CITY OF OREGON CITY

PLANNING COMMISSION

FILE NO.: PD 04-02

REQUEST: The applicant is requesting approval of a Planned Unit Development.

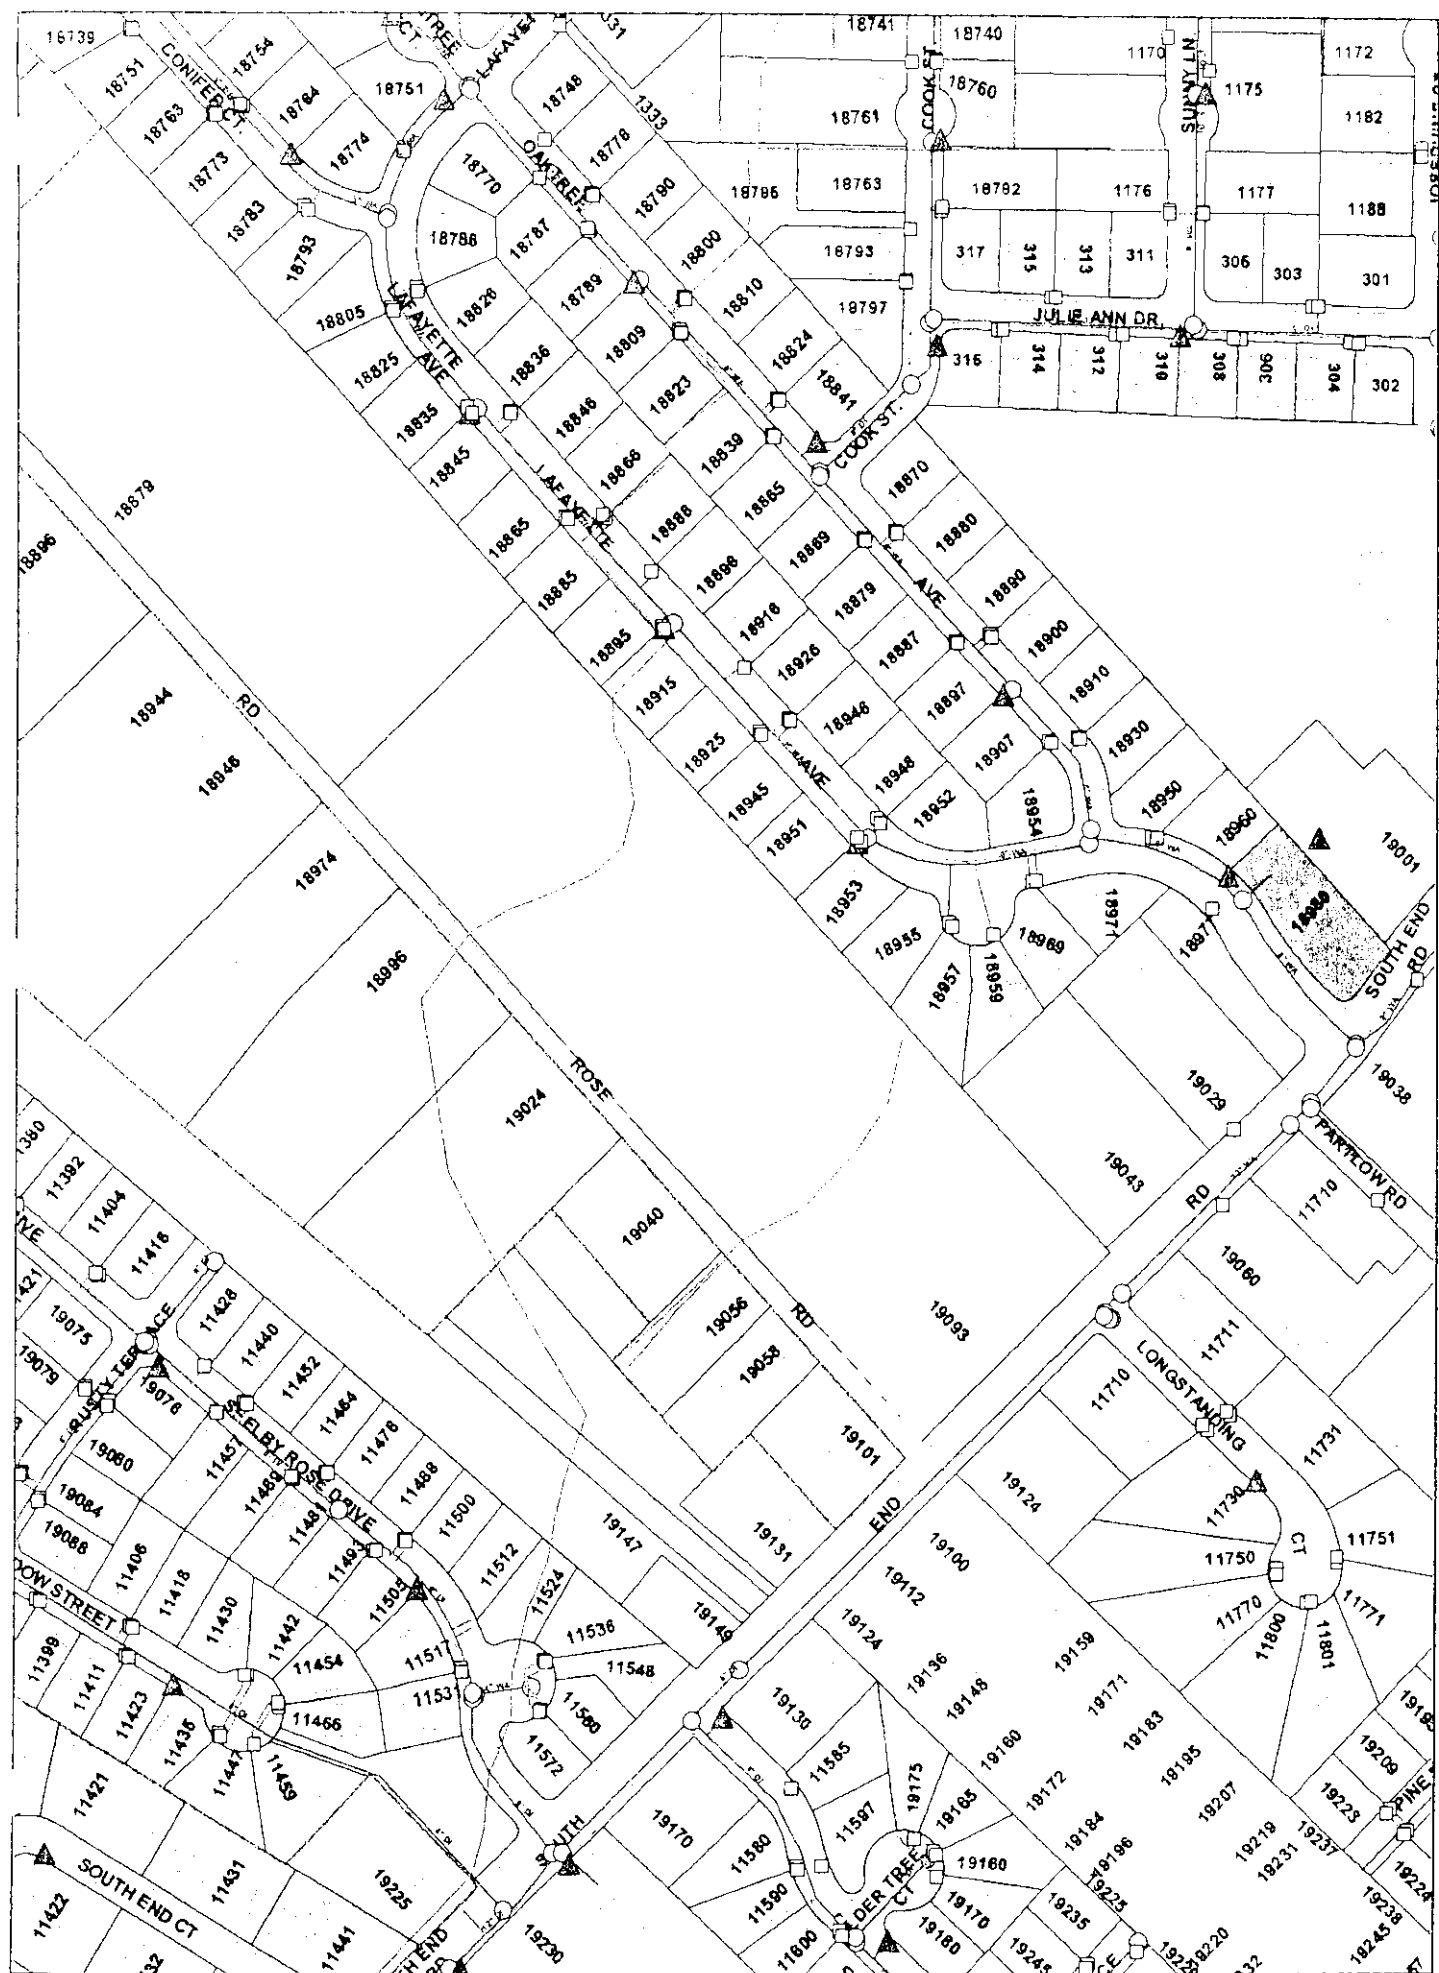
Water comments have been made on sheet #4. The proposed plan sheet shows a new 12" water main installed along Rose Road. An 8" DI is common, is there another need for the water main upsize? Fire hydrants should be installed on the same side of the road as the water main, not across the street. Keep the proposed water main separate from the existing OC water system until the PSI & BAT tests passes. A new fire hydrant should be installed along South End Road. See attached water map for details.
